Application No. A/NE-TKL/837

Section 16 Planning Application for Temporary Open Storage of Recycling Materials and Metalware with Ancillary Office for a Period of 3 Years at Lots 86 (Part), 87 and 89 in D.D. 83 and Adjoining Government Land, Kwan Tei North, Fanling, New Territories

Submission of Further Information 1

Responses to Departmental Comments

Swept Path Analysis

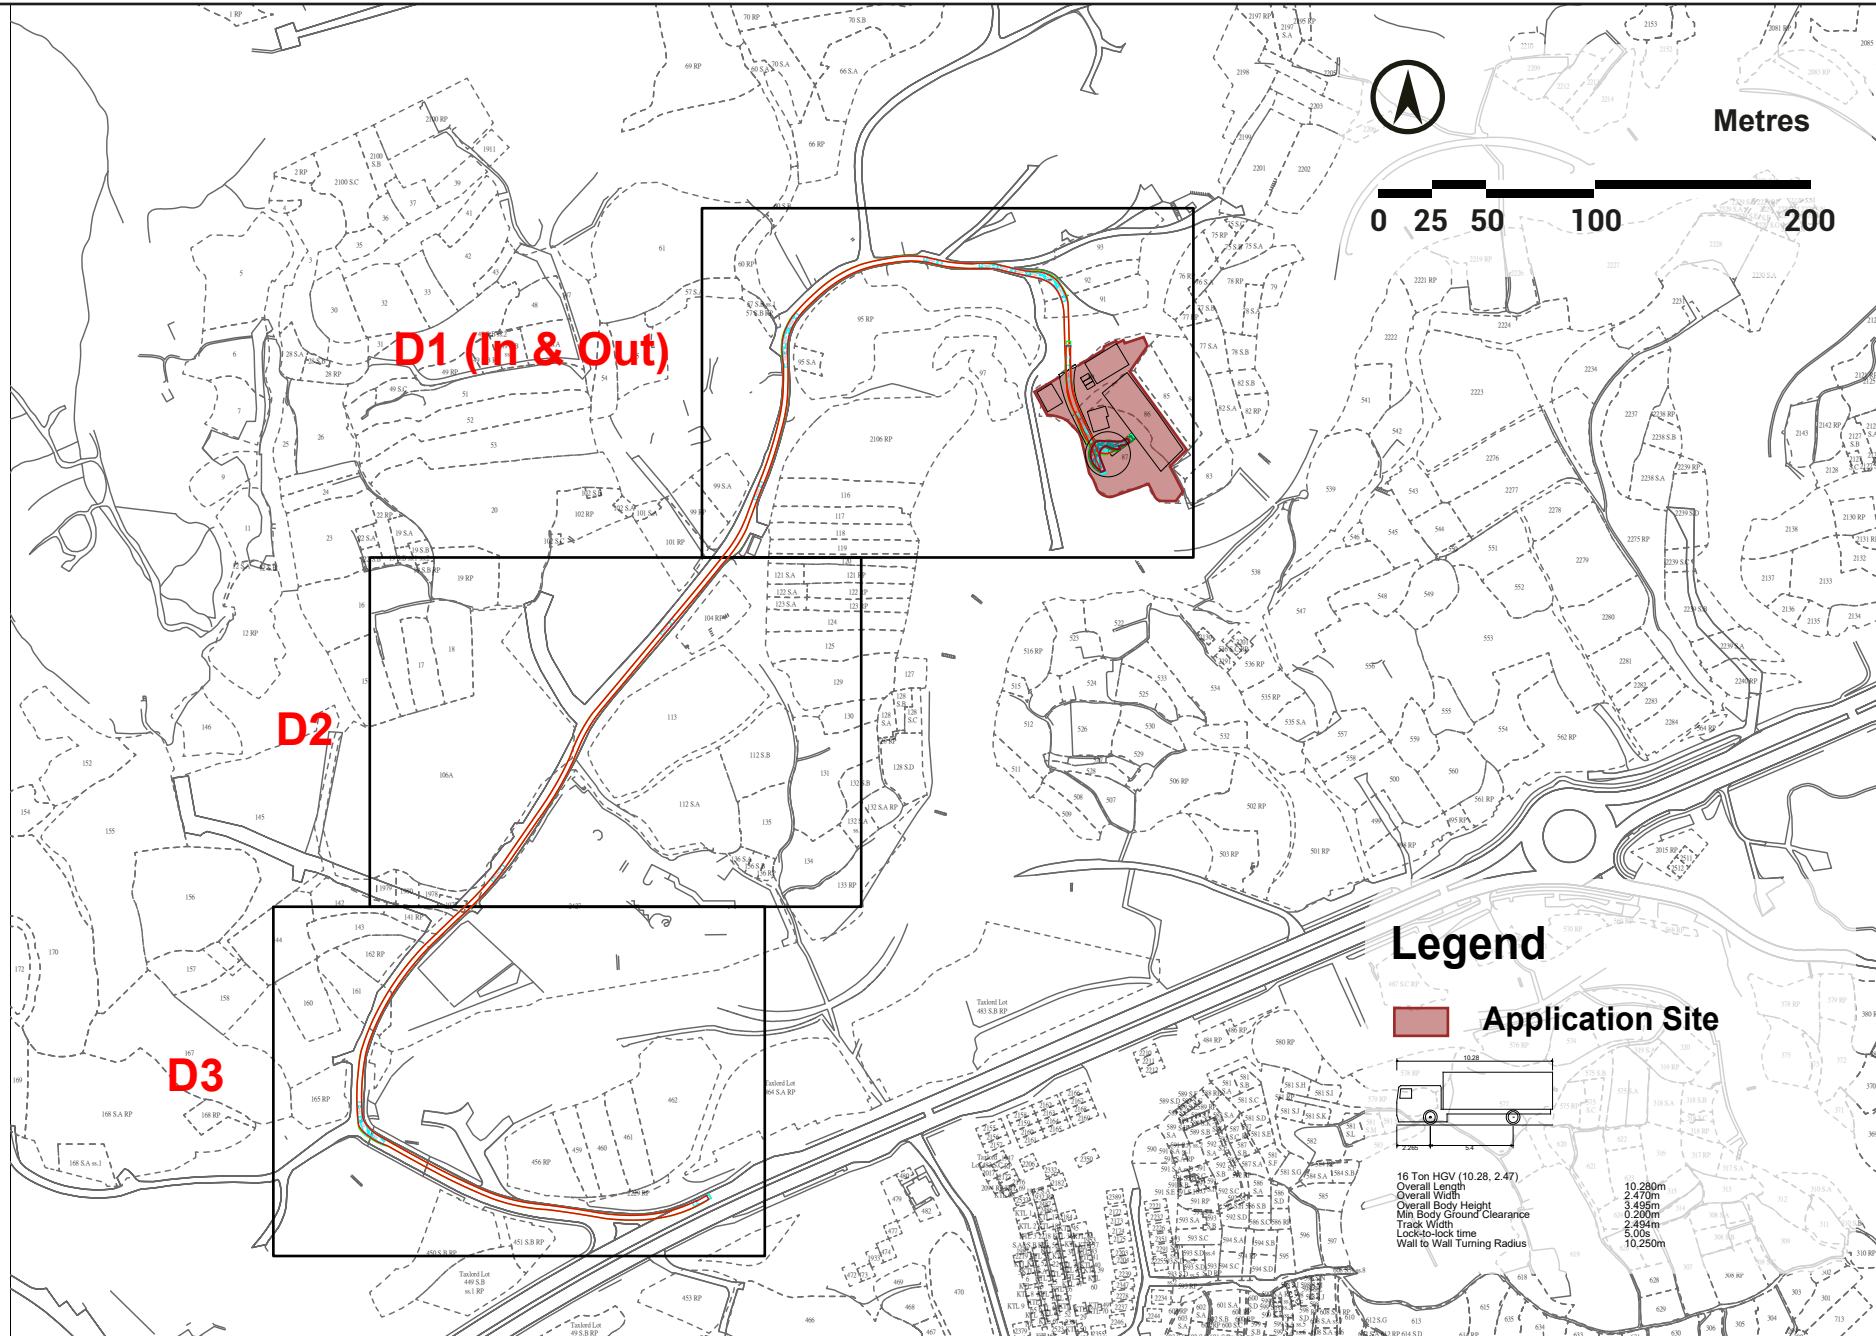
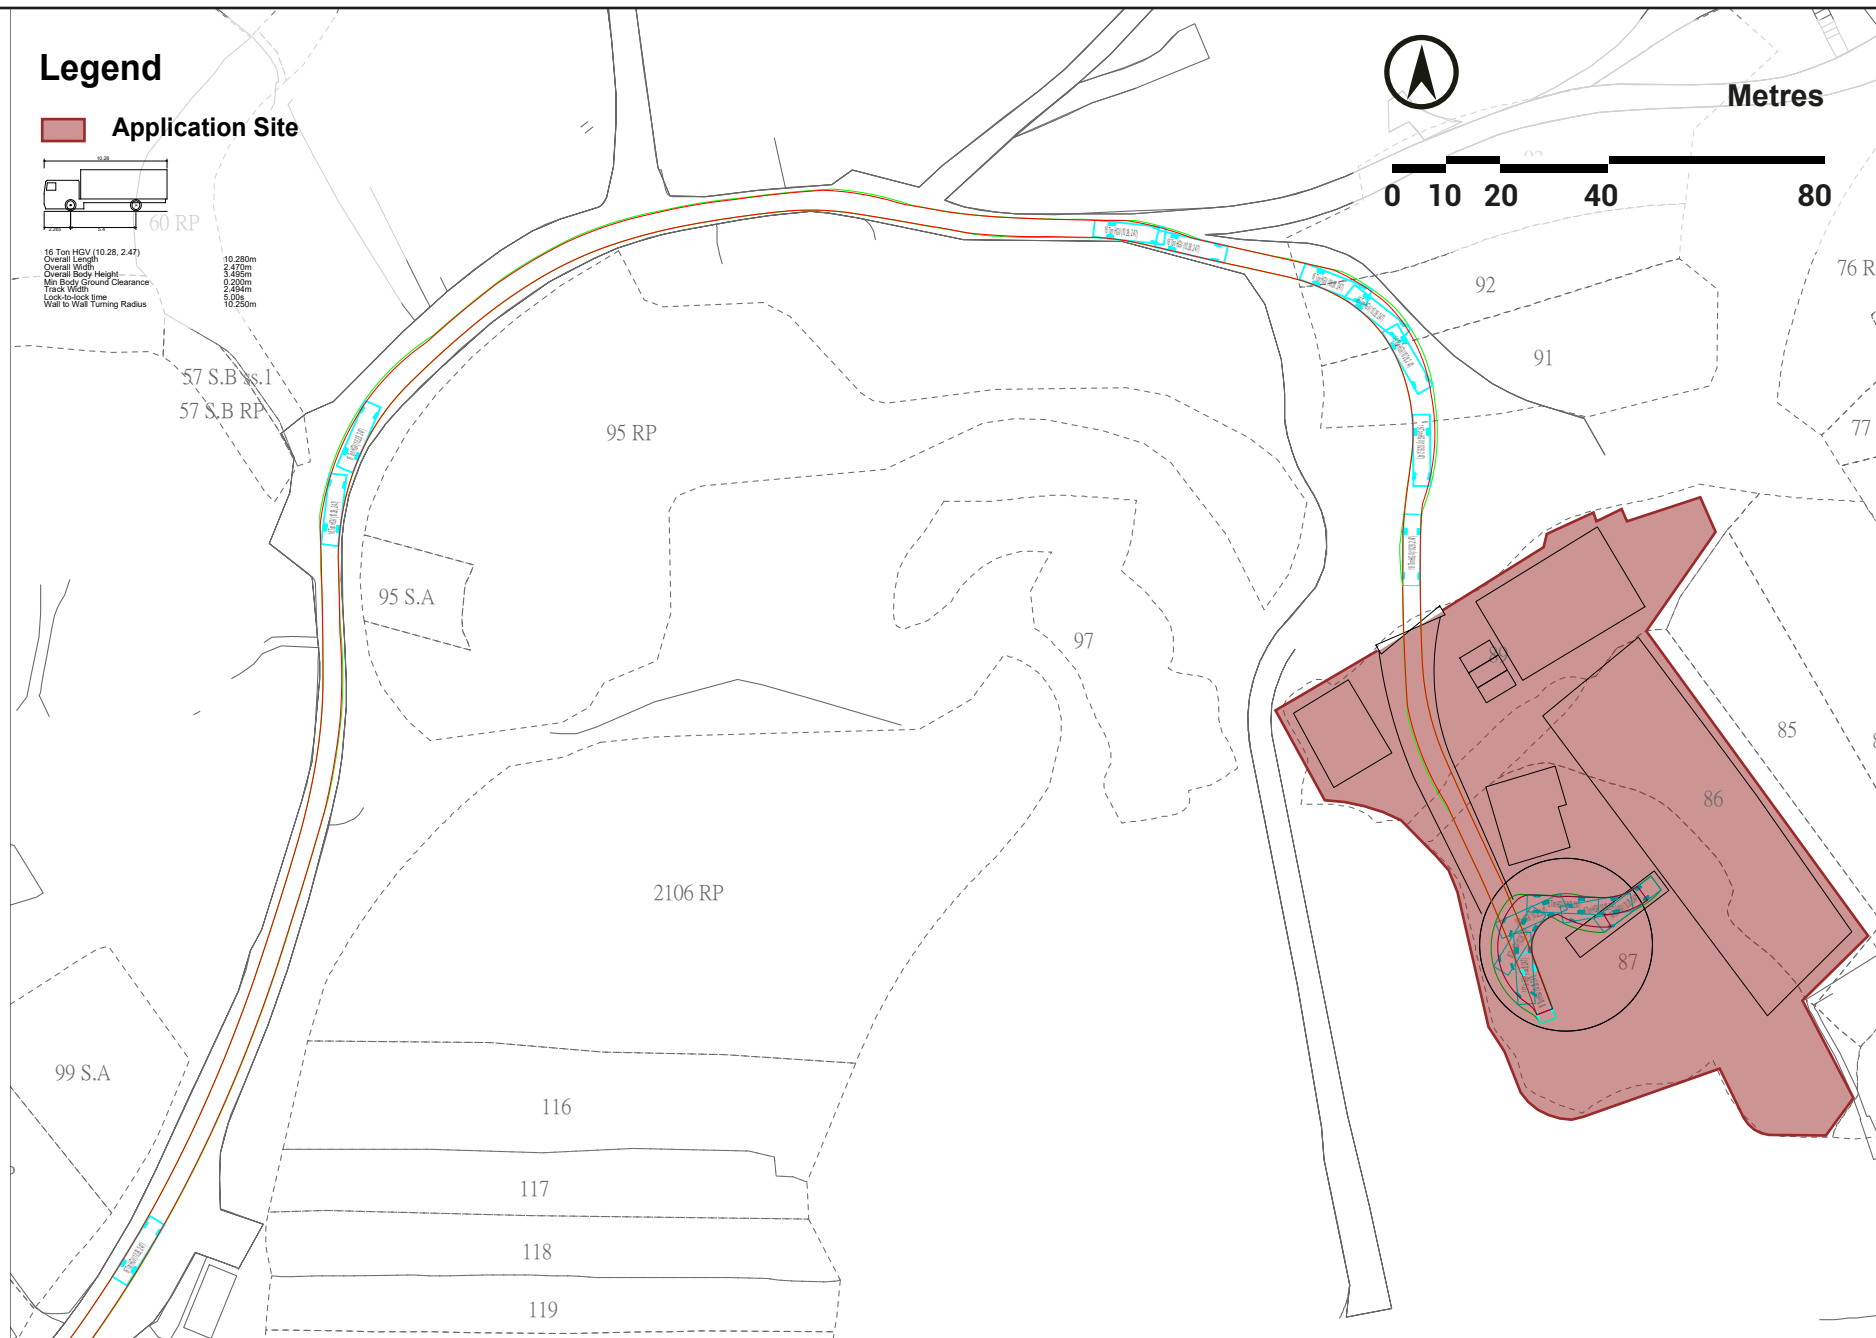
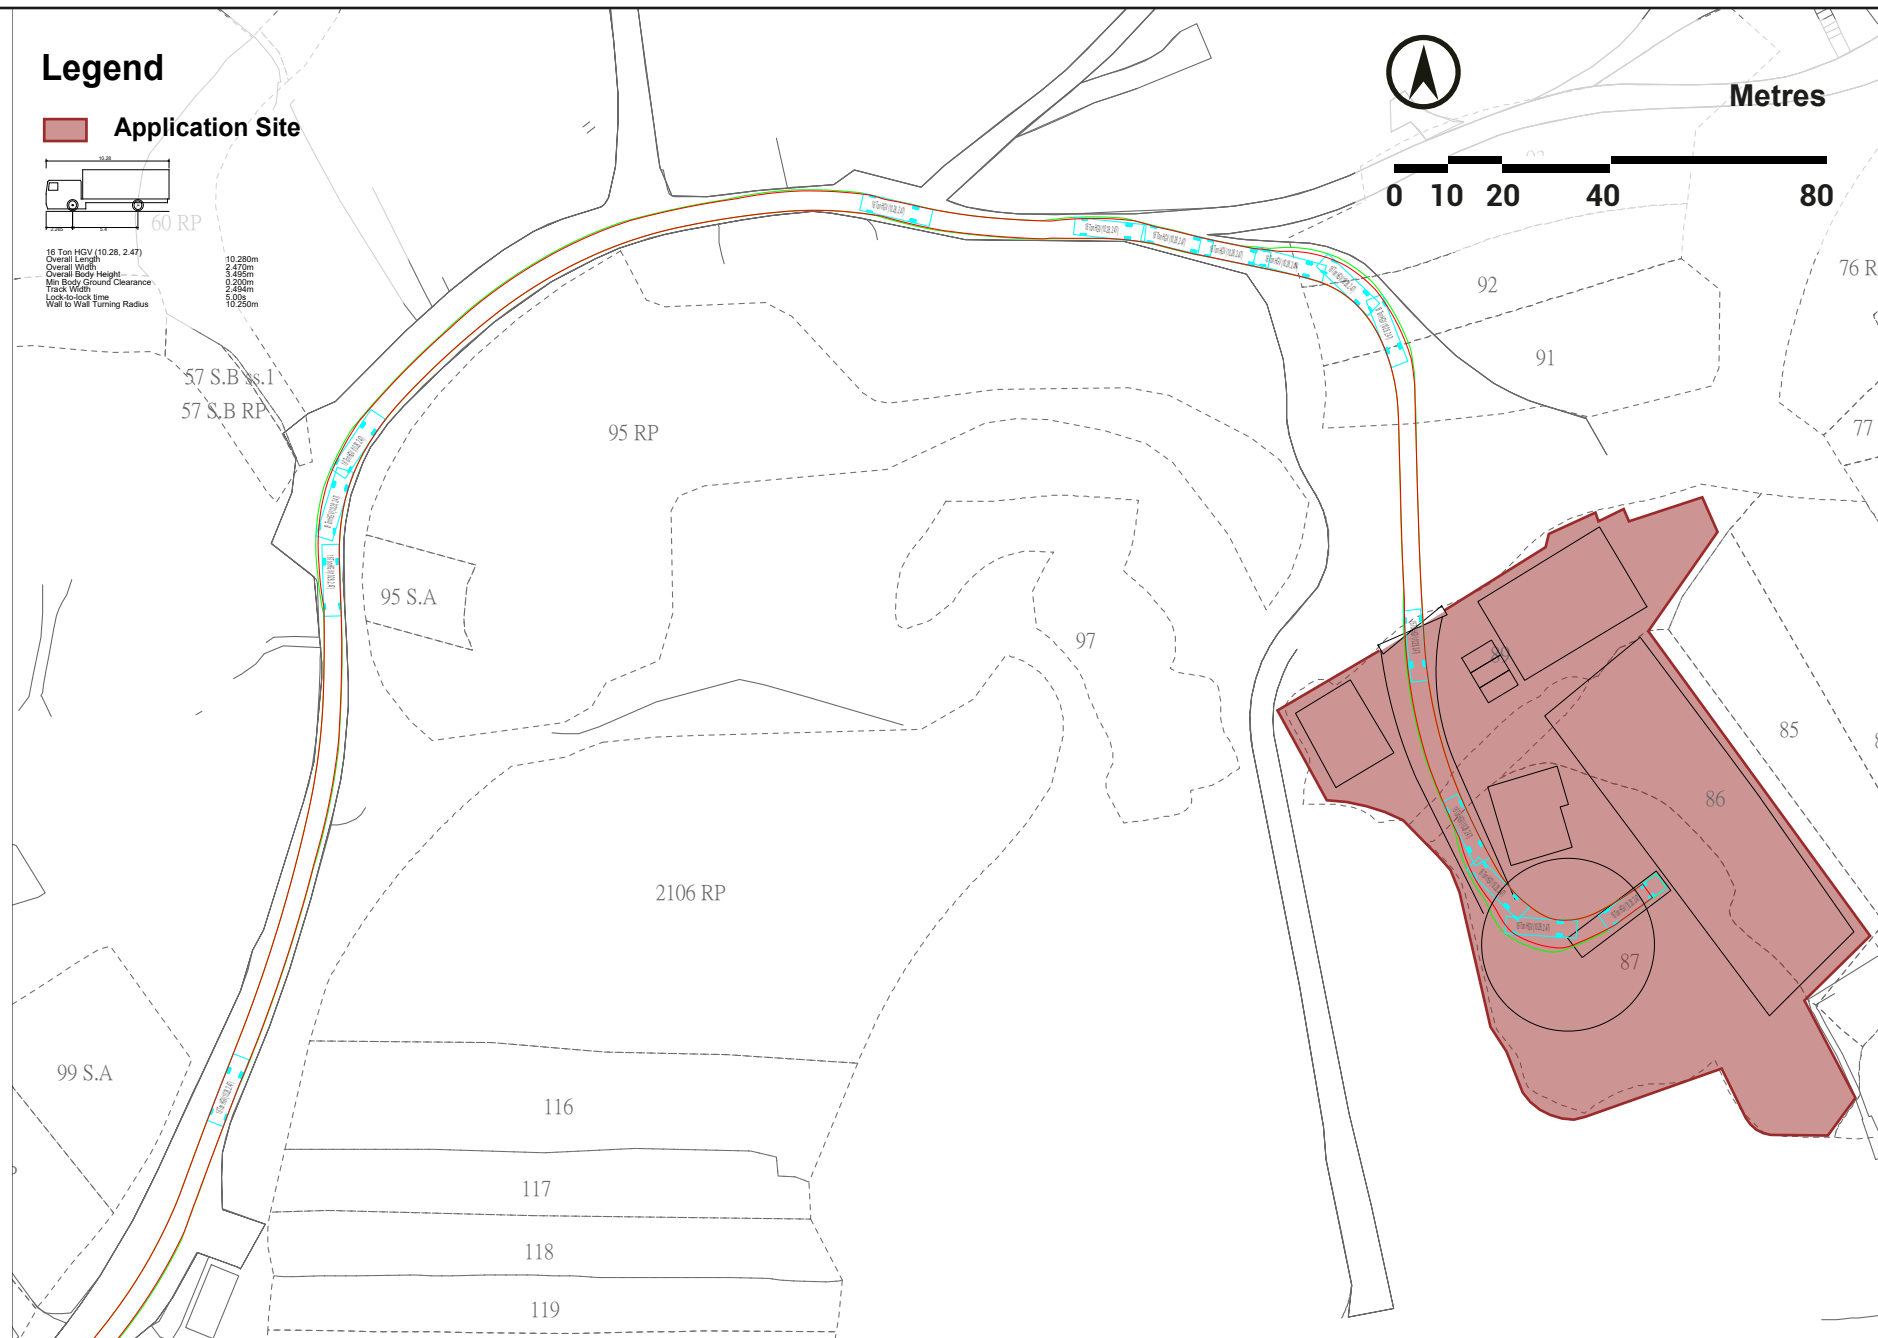
2.	Please supplement swept path analysis demonstrating satisfactory maneuvering of MGV-type vehicle to and from the development site;	According to the last approved application (No. A/NE-TKL/735), the Applicant submitted a swept path analysis for a 16-ton HGV, which indicates sufficient manoeuvring space for the MGV-type vehicle under the current application. Please refer to Annex 1 .
